**GE Hitachi Nuclear Energy**

Subject: **Response to Portion of NRC Request for Additional Information  
Letter Nos. 25 and 69 Related to ESBWR Design Certification  
Application – Safety Analyses – RAI Numbers 15.2-2S01 and  
15.3-11S01**

**Response to Portion of NRC Request for  
Additional Information Letter Nos. 25 and 69  
Related to ESBWR Design Certification Application**

**RAI Numbers 15.2-2 S01 and 15.3-11 S01**

Figure 15.3-11-1. Normalized Nodal Power Density Response

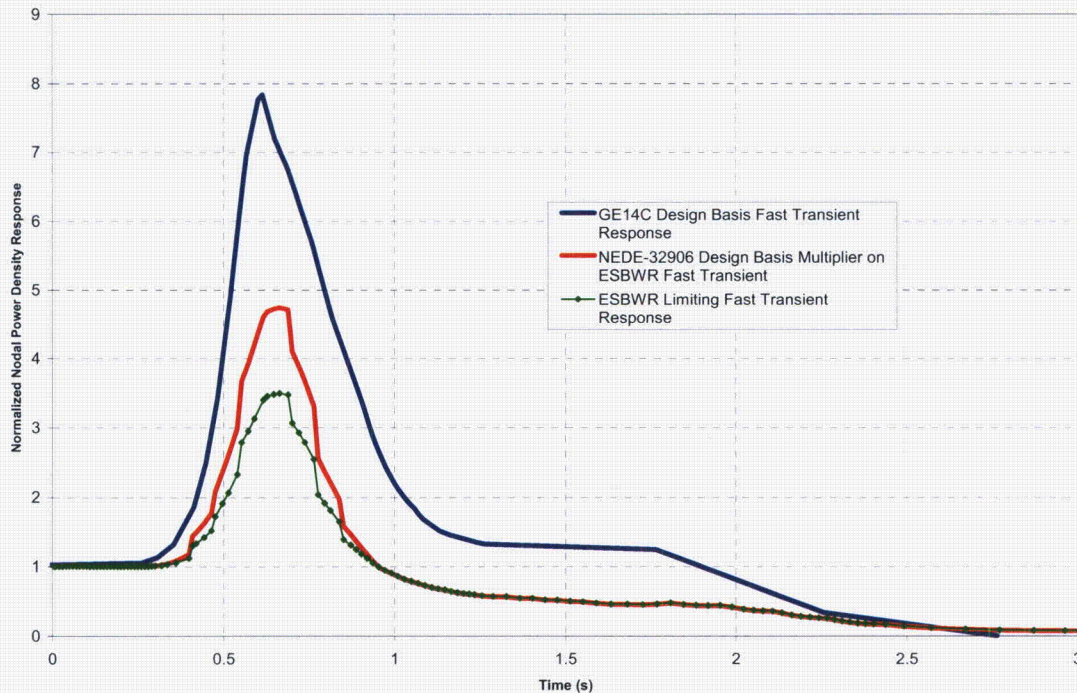
- 1. DCD Figure 15.3-4a indicates a sharp rise in total power (although the corresponding simulated power peak is not as pronounced) very much like control rod drop event. Please calculate the total power deposition and the corresponding cladding strain along with the pellet clad mechanical interaction for cladding strain.*
- 2. Generator load Rejection with Total Turbine Bypass Failure event results in a very short burst of energy. Please calculate the fuel energy deposition and the pellet cladding mechanical interaction for this transient.*

The Generator Load Rejection with Total Turbine Bypass Failure, also known as the Load Rejection No Bypass (LRNBP) event clearly has the most severe response of the two transients discussed in the RAI. In fact (as shown in DCD Tier 2, Revision 4, Tables 15.2-5 and 15.3-1), this event bounds all ESBWR fast core-wide Anticipated Operational Occurrences and Infrequent Events. As noted in Reference 15.3-11-1, the heat flux remains very low with respect to the acceptance criteria for GE14 fuel. For fast transients, like LRNBP (Infrequent Event category for ESBWR), the heat flux is not as effective in determining the margin to centerline melt and cladding circumferential strain (because of the thermal inertia of the rod). Current methodology accepts that if the nodal power evolution of any node in the core during a transient is bounded by the generic Normalized Nodal Power Density (NNPD) used to define the fast transient limits, then the thermal-mechanical Limits are not threatened.

The NNPD for the LRNBP has been extracted and penalized with a 1.5 factor, as documented in Reference 15.3-11-2, and compared with the generic GE14 NNPD curve (see Figure 15.3-11-1). This factor is a significant conservatism and is considered applicable and bounding for the ESBWR. As discussed in Reference 15.3-11-1 the GE14 and GE14E fuels are very similar, and the generic GE14 NNPD curve for fast transients can be applied to GE14E fuel.

Significant margin exists to the generic NNPD, therefore, the ESBWR is expected to have significant margins for cladding strain and fuel melt criteria as listed in DCD Tier 2, Revision 4, Table 15.0-3. To clarify the DCD with respect to the thermal-mechanical evaluation, DCD Tier 2 changes are listed below.
